Colorado Department  
of Public Health  
and Environment

## EXPLANATION OF SIGNIFICANT DIFFERENCE FOR THE SUMMITVILLE MINE SUPERFUND SITE

### FACT SHEET

Figure 1

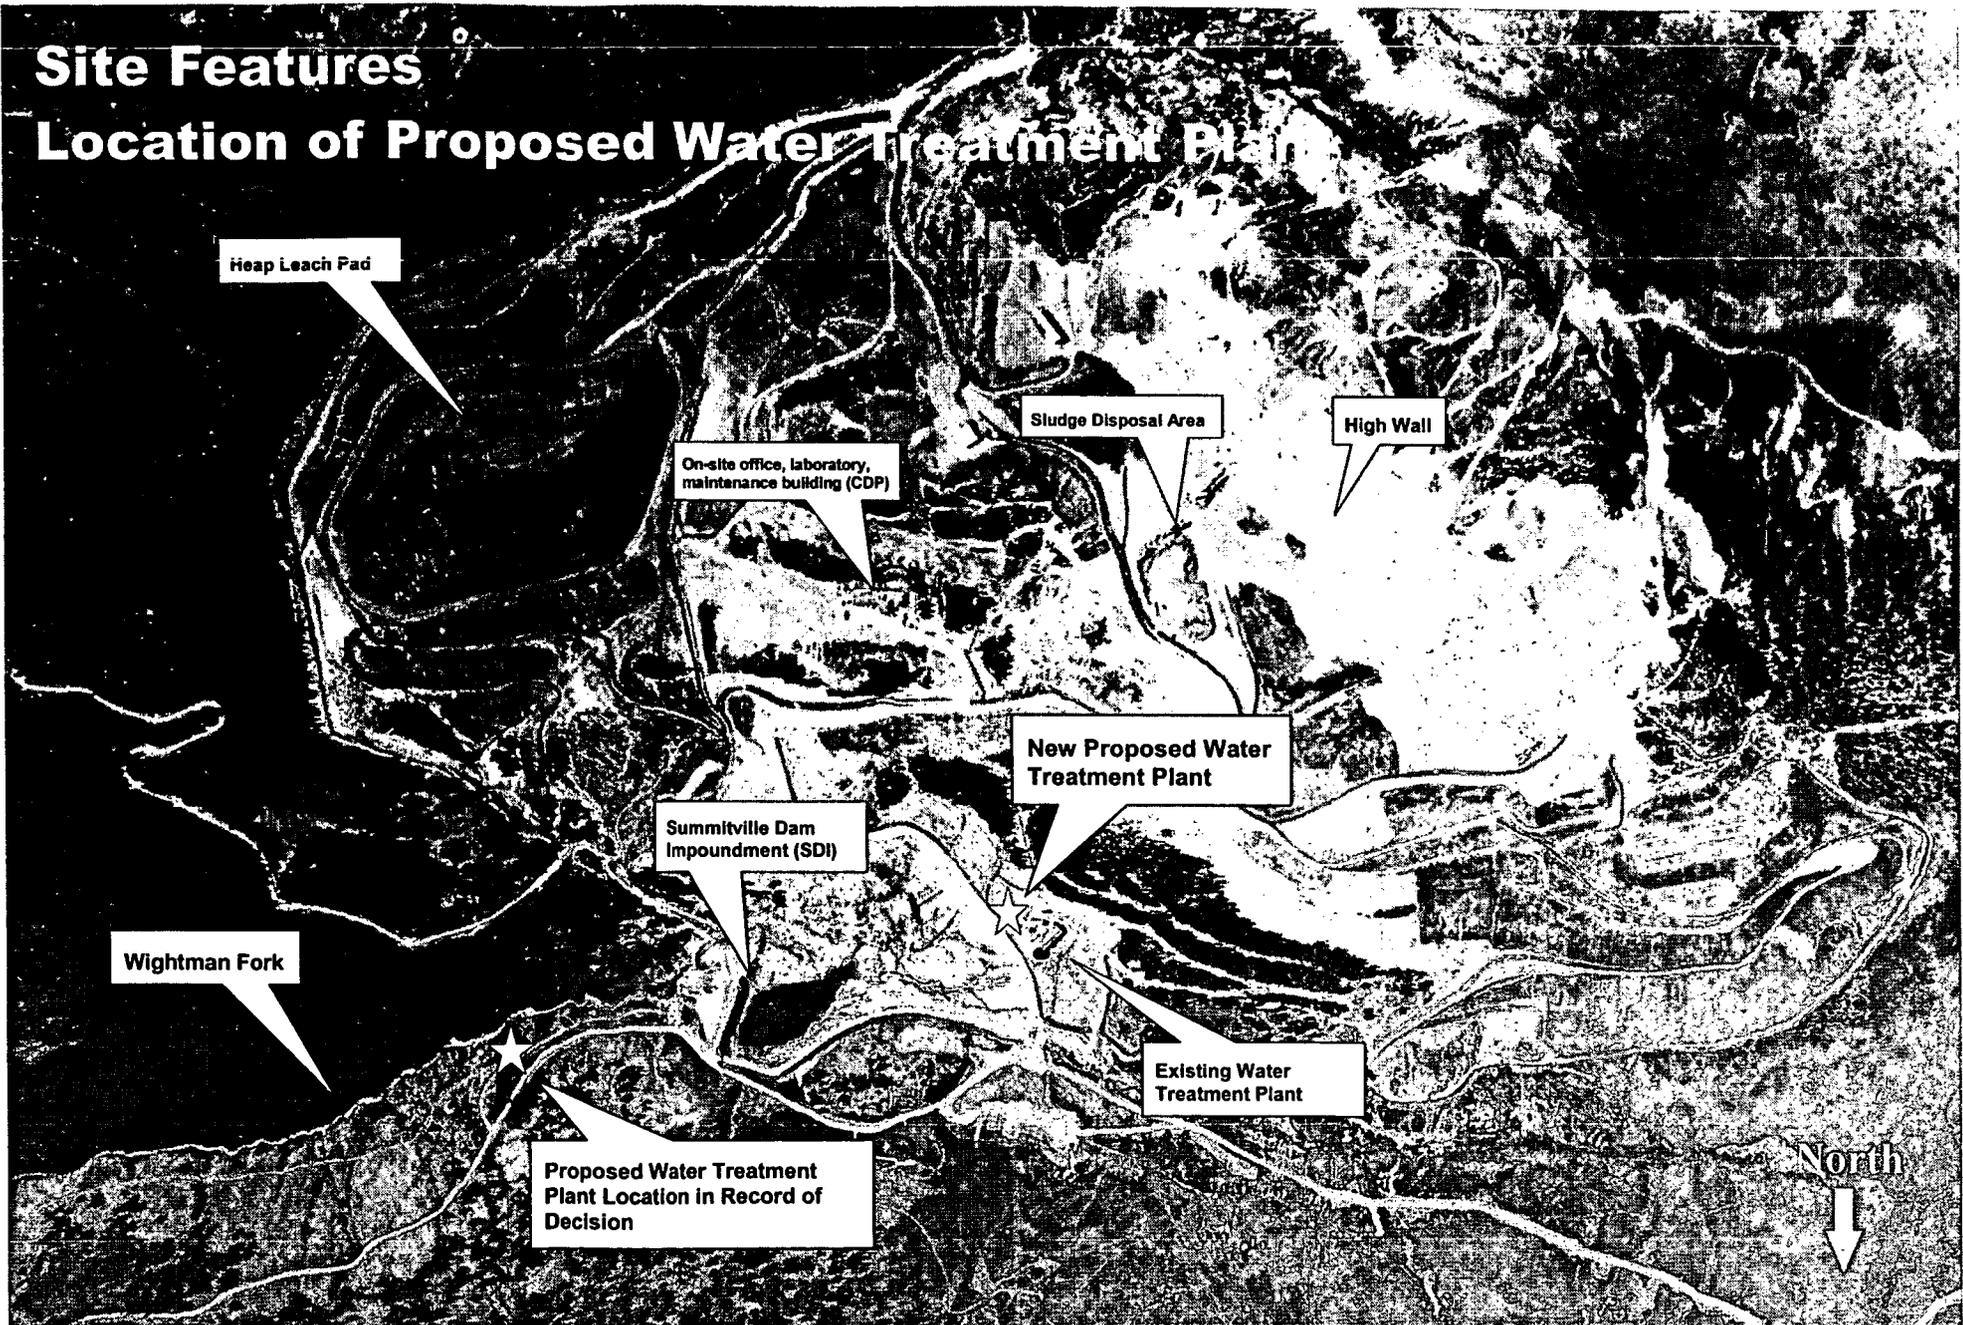
The location adjacent to the existing water treatment plant proved to be the most economical, while still adhering to the remedial goals and cleanup requirements specified in the ROD. This ESD proposes to change the location of the new WTP from downstream of the storage impoundment to a location adjacent to the existing WTP (Figure 1).

ROD-Prescribed Remedy	Modification
1. A new, conventional water treatment plant will be constructed downstream of the on-site impoundment, outside of the 500-year flood plain.	The new water treatment plant will not be located downstream of the storage impoundment, but rather located at the same location as the existing water treatment plant, which is outside of the 500-year floodplain.
2. The new plant will be at an elevation such that sufficient pressure will be available to provide gravity operation of the plant.	The contaminated water will be pumped to the new plant rather than delivered by gravity feed.
